**Subject: Rumford Falls Hydroelectric Project (FERC No. 2333)  
Comments on Draft Water Quality Certification (MDEP Application #L-024307-33-G-N)**

Attachment A – Rumford Falls Hydro LLC's comments on the Draft Water Quality Certification for the Rumford Falls Hydroelectric Project (FERC Project No. 2333)

**Figure 5.6-4. Suitable Habitat and Discharge for Target Species in the Middle Dam Bypass Reach. Upper Figure Shows Habitat Based on the DFA Analysis, Lower Figure Based on the 1-D Analysis (RFH 2022)**

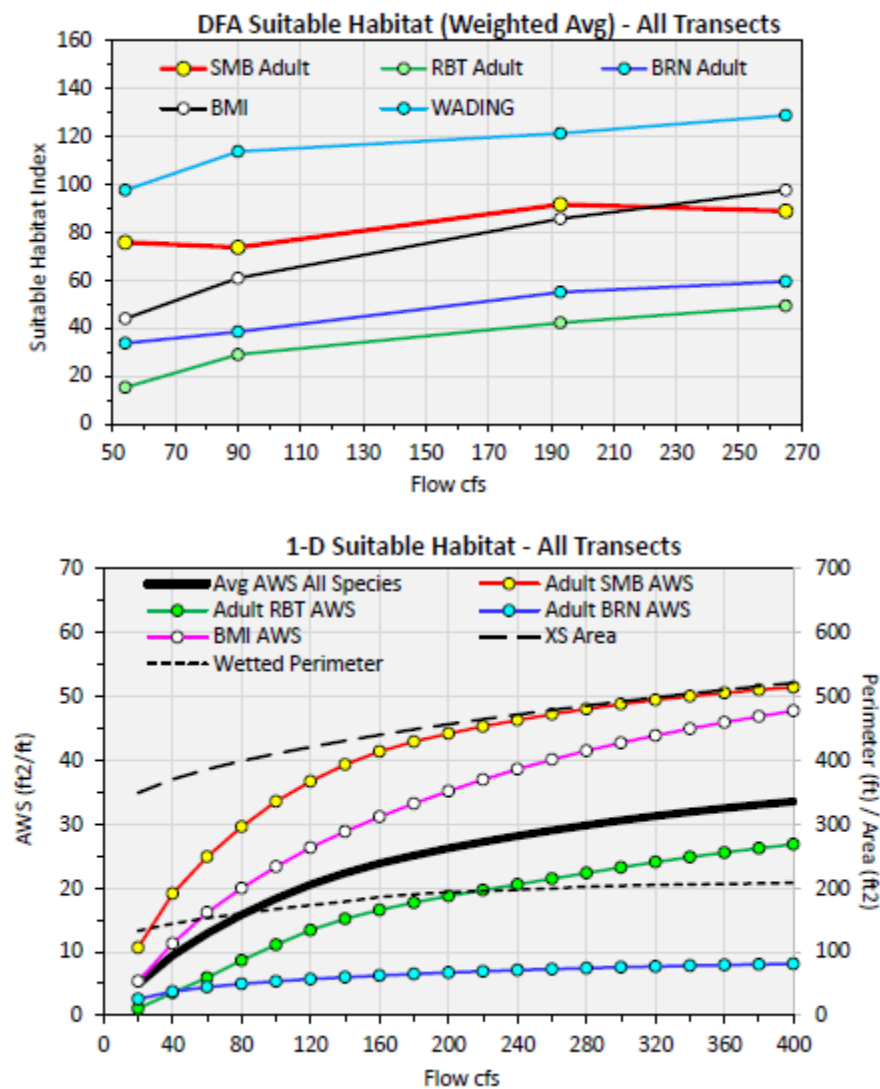
... (Figure 5.6-4) shows that wading suitability increases rapidly from 54 to 90 cfs, but minimal increase in wading habitat occurs at higher flows. The gain in wading habitat from 90 cfs to 265 cfs is only 12 percent, despite almost a three-fold increase in flow."

**Figure 5.6-5. Percent Increase in Suitable Habitat (AWS) per 20 cfs Increment in Flow for Target Species in the Middle Dam Bypass Reach (RFH 2022)**

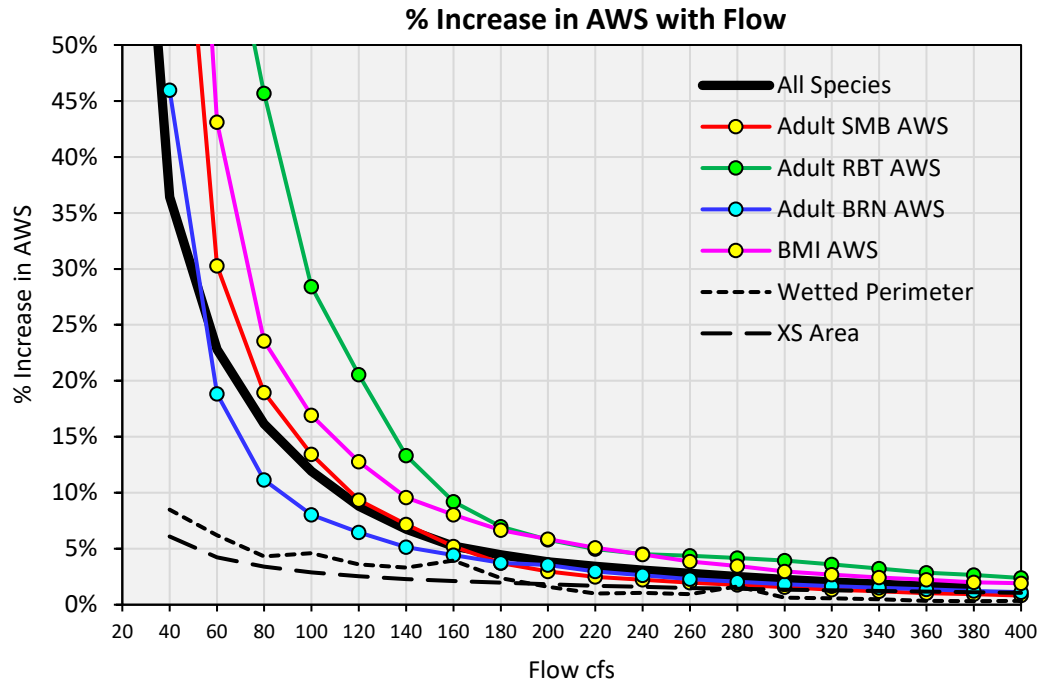
“The Flow Study for Aquatic Habitat Evaluation study looked specifically at the relationship between the Middle Dam bypass reach flows and the quantity of suitable habitat for several species of fish, as well as macroinvertebrates. Both the qualitative Demonstration Flow Analysis (DFA) and the quantitative one-dimensional (1-D) modeling results showed that the amount of suitable habitat continues to increase up to the maximum measured or modeled flows (DFA included flows up to 265 cfs; 1-D modeling included flows from 20 cfs to 400 cfs in 20 cfs increments) for most target species (See Figure 5.6-4 ...). However, the rate of increase in habitat with increase in flow declines as flows exceed 100 cfs to 150 cfs (See Figure 5.6-5 ...). For example, gains in habitat are only 10 percent or less per 20 cfs increment at flows of 80 cfs to 160 cfs. This trend is not only seen for the target fish species, but for BMI as well, which were also shown by the BMI study to fulfill Class A standards under existing flow conditions. Even lower gains in physical habitat as measured by cross-sectional areas (ft<sup>2</sup>) or wetted perimeter (ft) are evident, with changes less than 5 percent per 20 cfs flow increment for all flows over 80 cfs (RFH 2022).
